Gachsaran Polymer Industries Company PIDMCO	Gachsaran Polymer Industries Company HDPE Plant		
	General Arrangement Drawing (2D) (Tie-In Points , Skid Dimensions & Orientation, Including Instrument, Junction Box and Local Panel Location Layout & Instrument Cable routing.) for Refrigerator Package	 	
PO No.: GPIC-PT-MA-PO-000-3029	Document Number: VD-GPIC-MA-3029-3029-0062	Rev. 04	Page 1 of 12

General Arrangement Drawing (2D) (Tie-In Points , Skid Dimensions & Orientation, Including Instrument, Junction Box and Local Panel Location Layout & Instrument Cable routing.) for Refrigerator Package

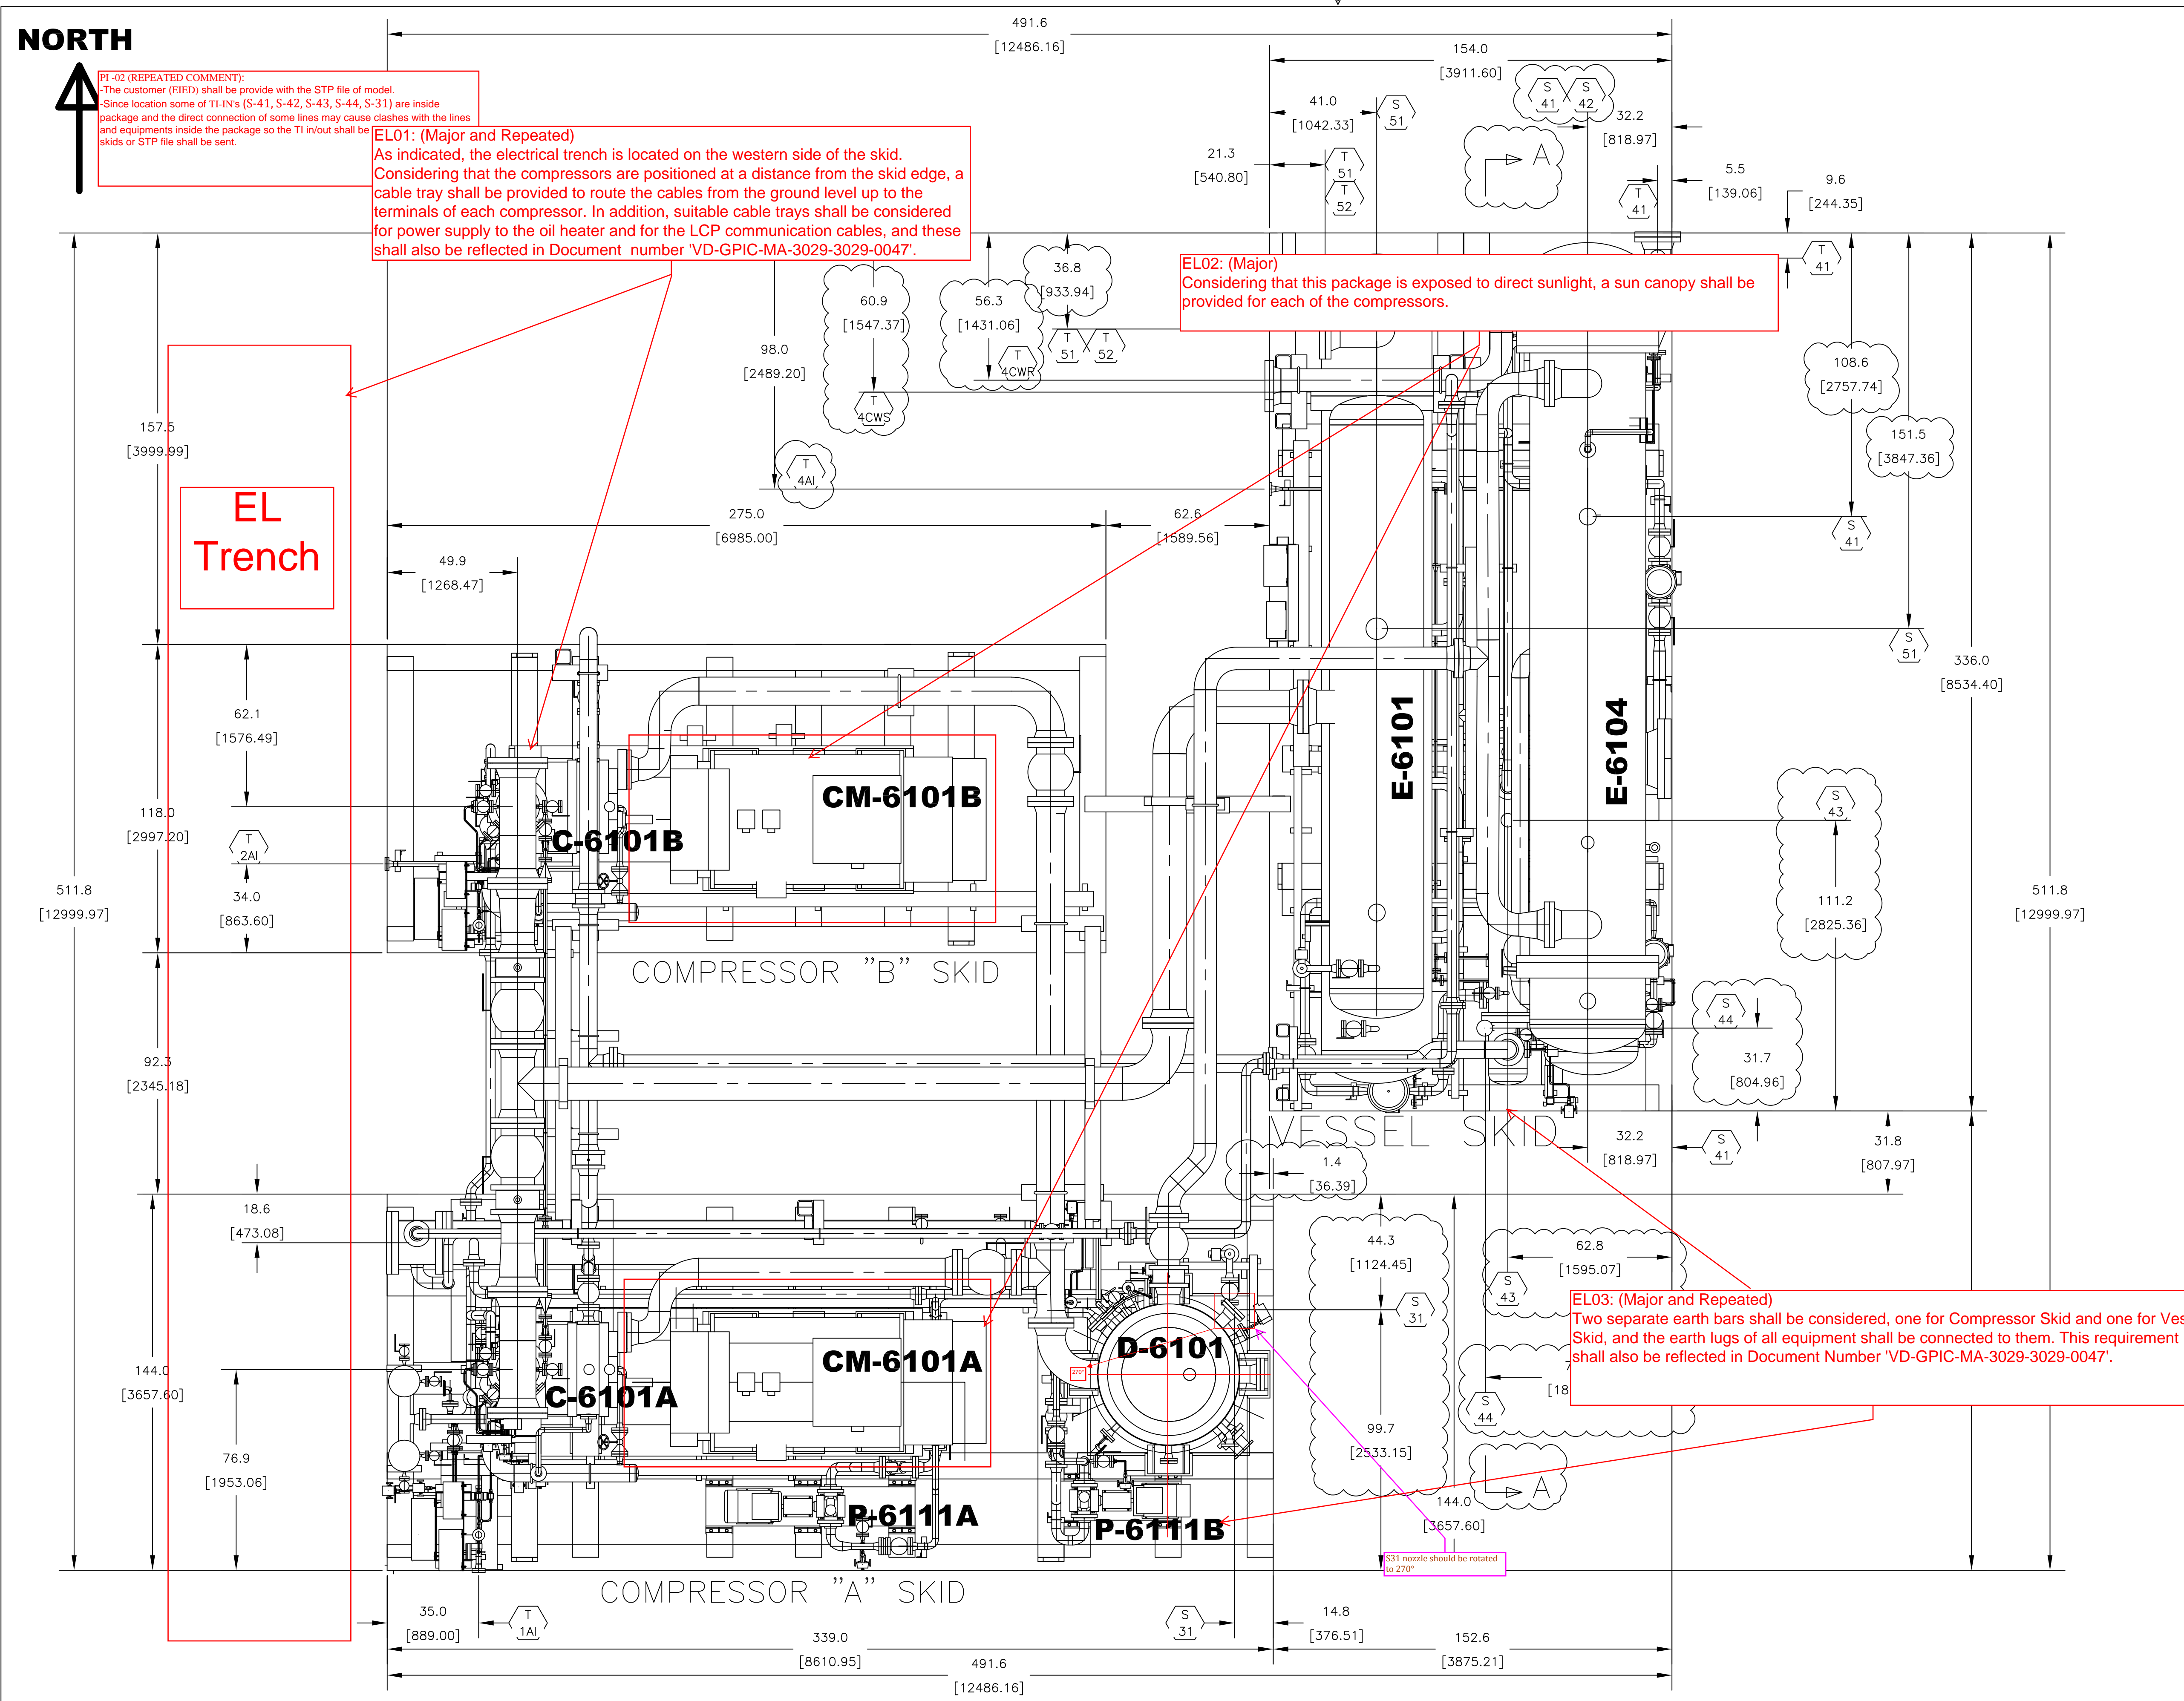
PI-02 (REPEATED COMMENT):
The customer (EIED) shall be provided with the STP file of model.
Since location some of TI-INs (S-41, S-42, S-43, S-44, S-31) are inside package and the direct connection of some lines may cause clashes with the lines and equipments inside the package so the TI in/out shall be skids or STP file shall be sent.

EL01: (Major and Repeated)
As indicated, the electrical trench is located on the western side of the skid. Considering that the compressors are positioned at a distance from the skid edge, a cable tray shall be provided to route the cables from the ground level up to the terminals of each compressor. In addition, suitable cable trays shall be considered for power supply to the oil heater and for the LCP communication cables, and these shall also be reflected in Document number 'VD-GPIC-MA-3029-3029-0047'.

EL02: (Major)
Considering that this package is exposed to direct sunlight, a sun canopy shall be provided for each of the compressors.

EL03: (Major and Repeated)
Two separate earth bars shall be considered, one for Compressor Skid and one for Vessel Skid, and the earth lugs of all equipment shall be connected to them. This requirement shall also be reflected in Document Number 'VD-GPIC-MA-3029-3029-0047'.

FRONT VIEW

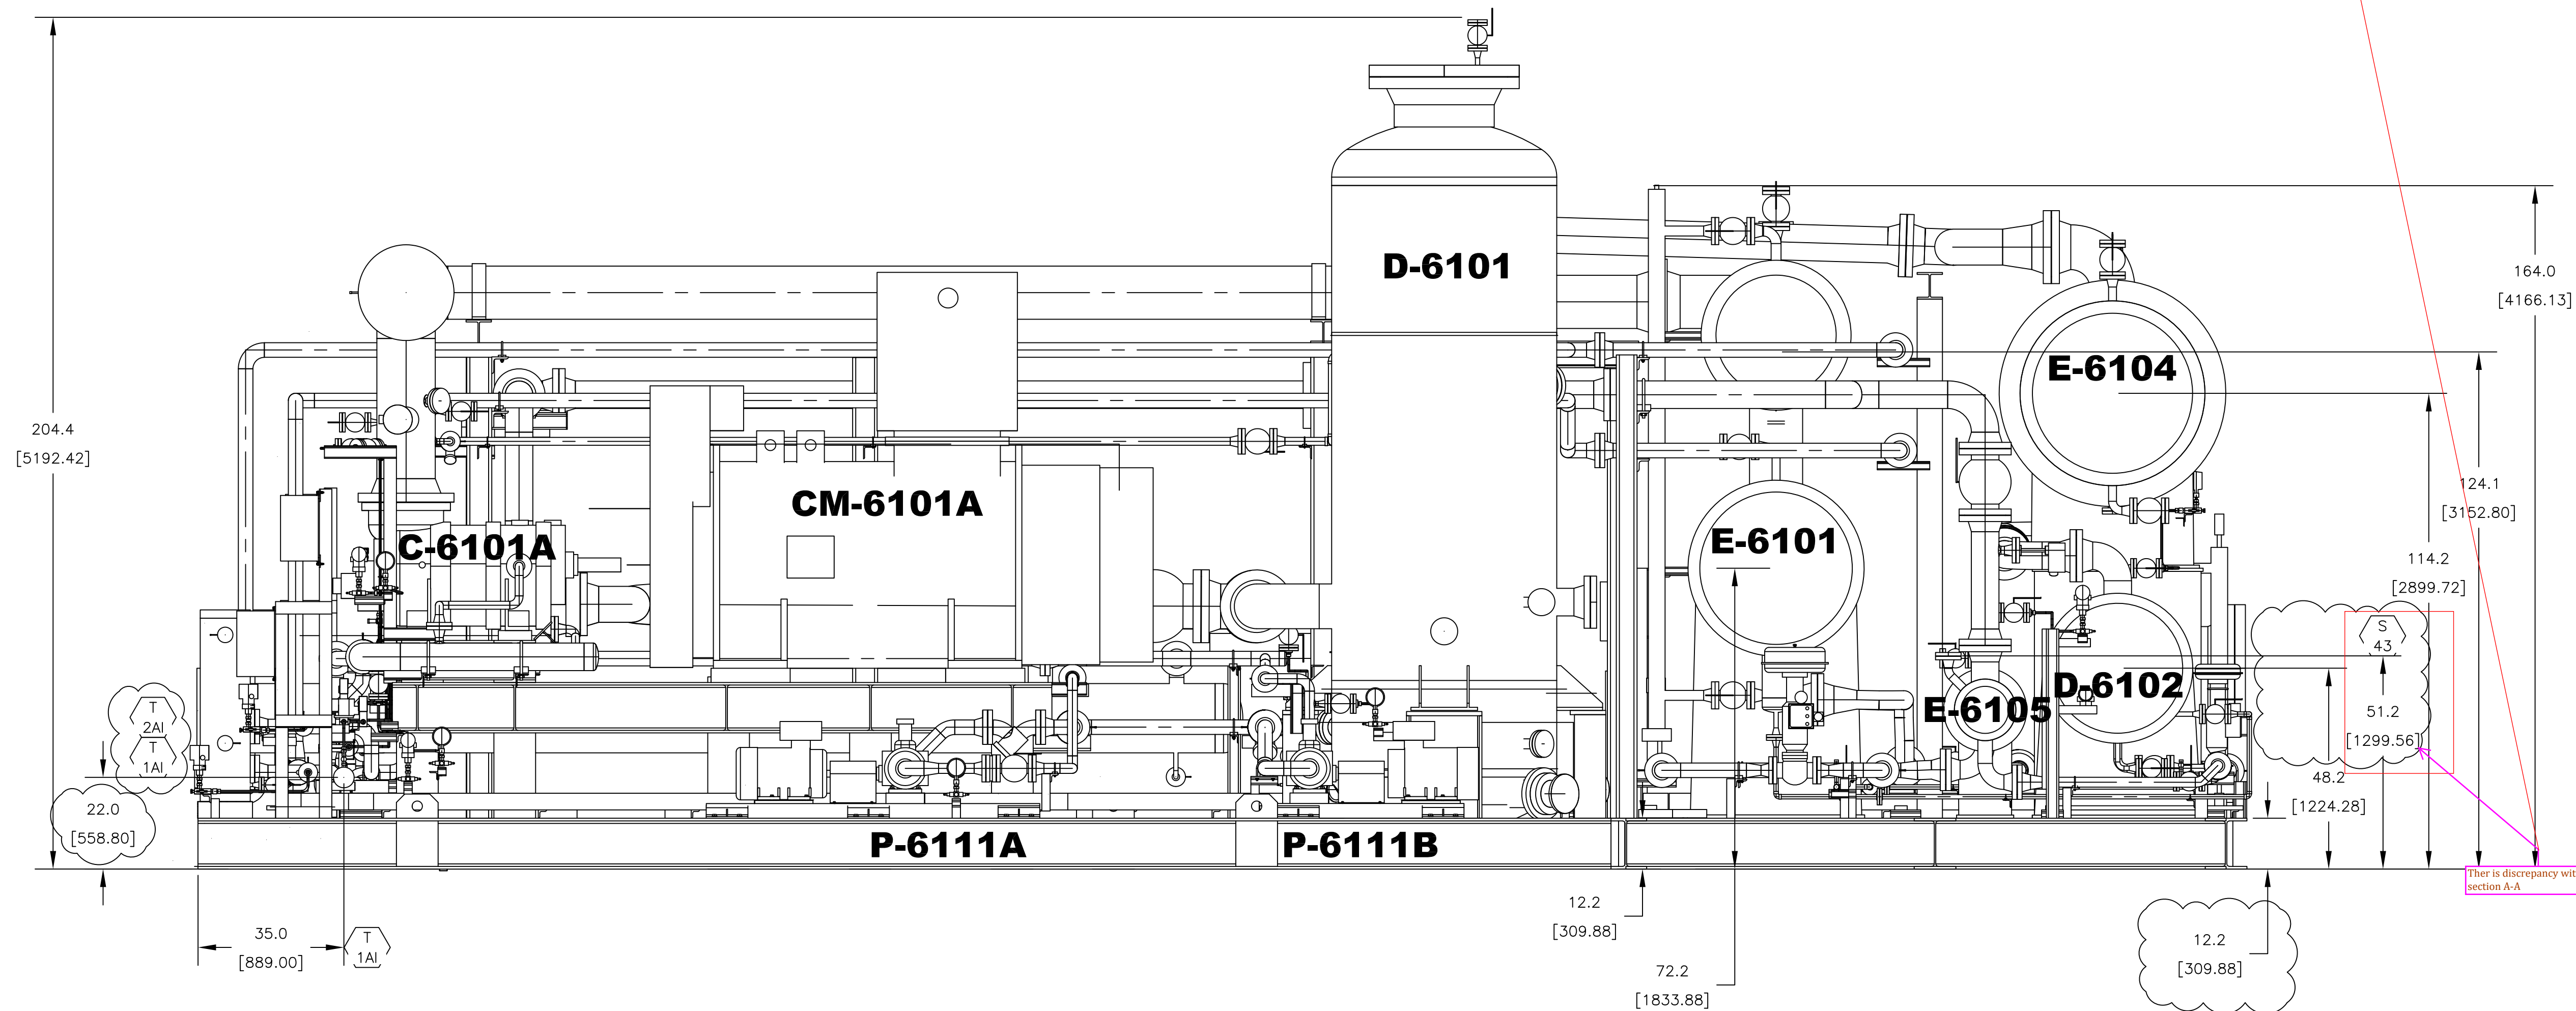
There is discrepancy with section A-A

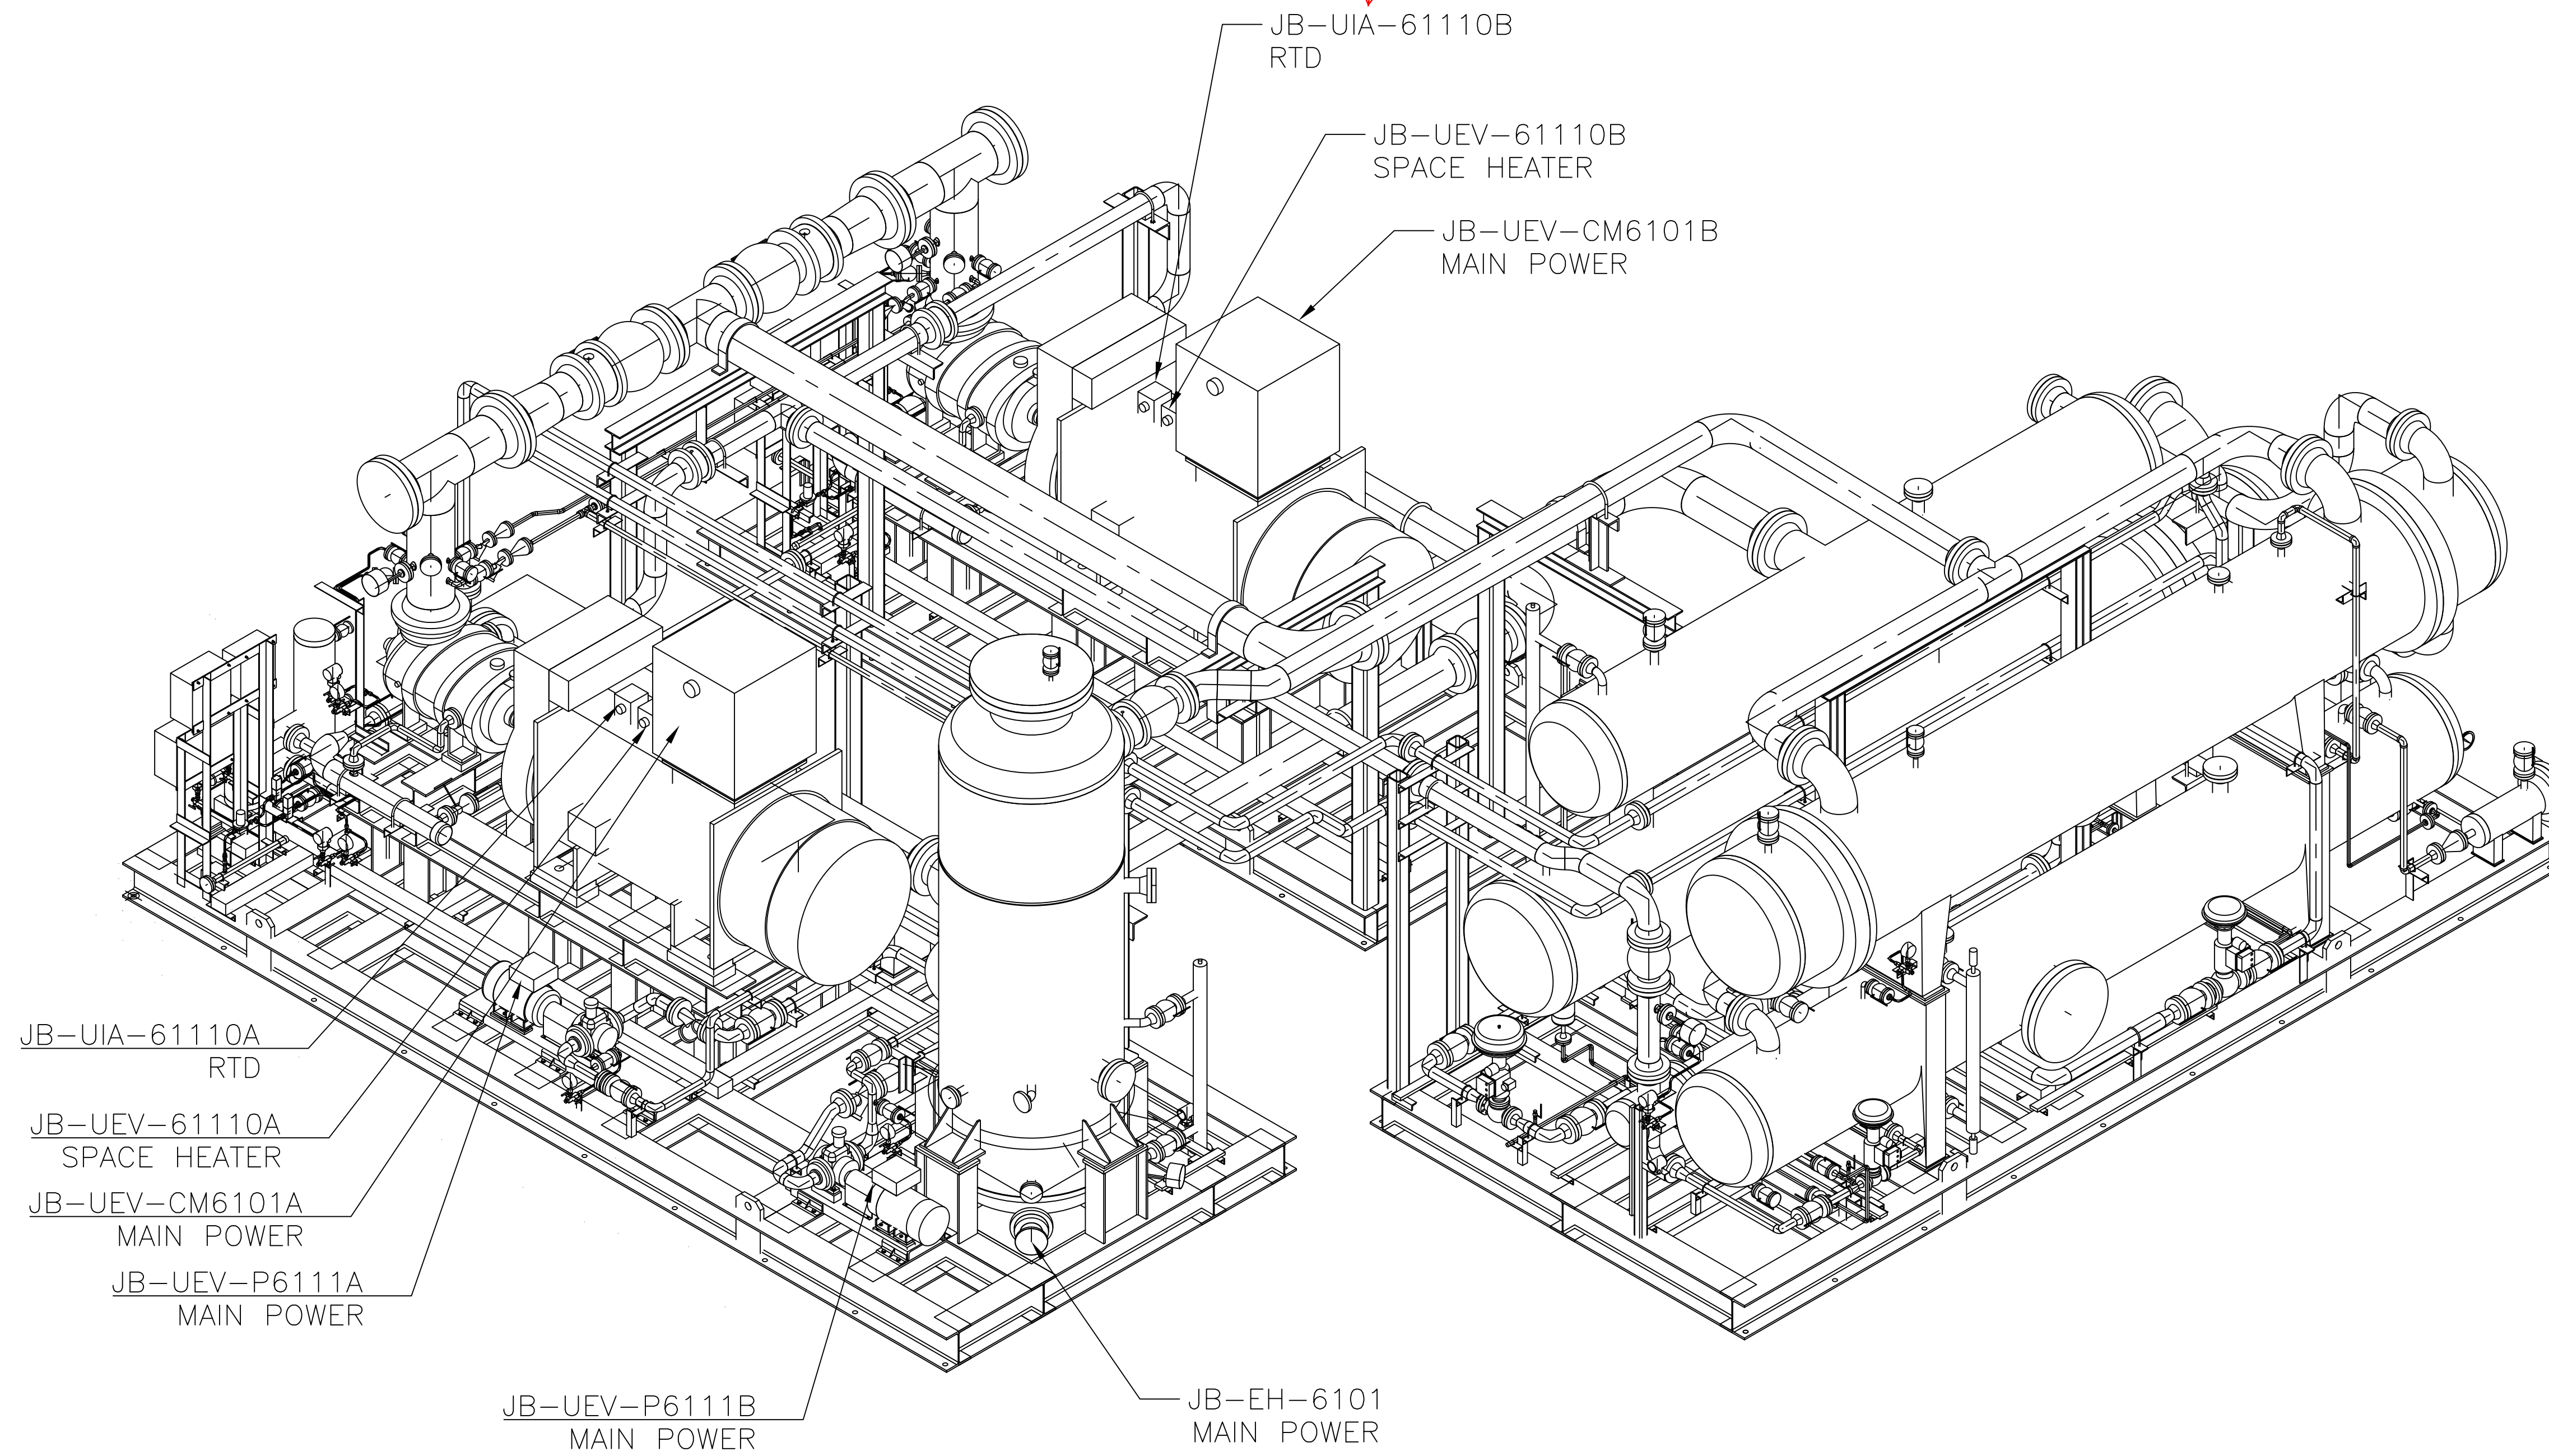
IN-02 Tag number of all JB and LCP shall be corrected based on final revision of IO list.

IN-01. In addition to GA, this document is cable route and for cable route, symbol for instrument cable tray/ladder/conduit/JB shall be specified clearly in symbol and legend and related cable route shall be shown in the drawing. Width/depth/size of trays/ladders/conduits shall be added and shown in this drawing.
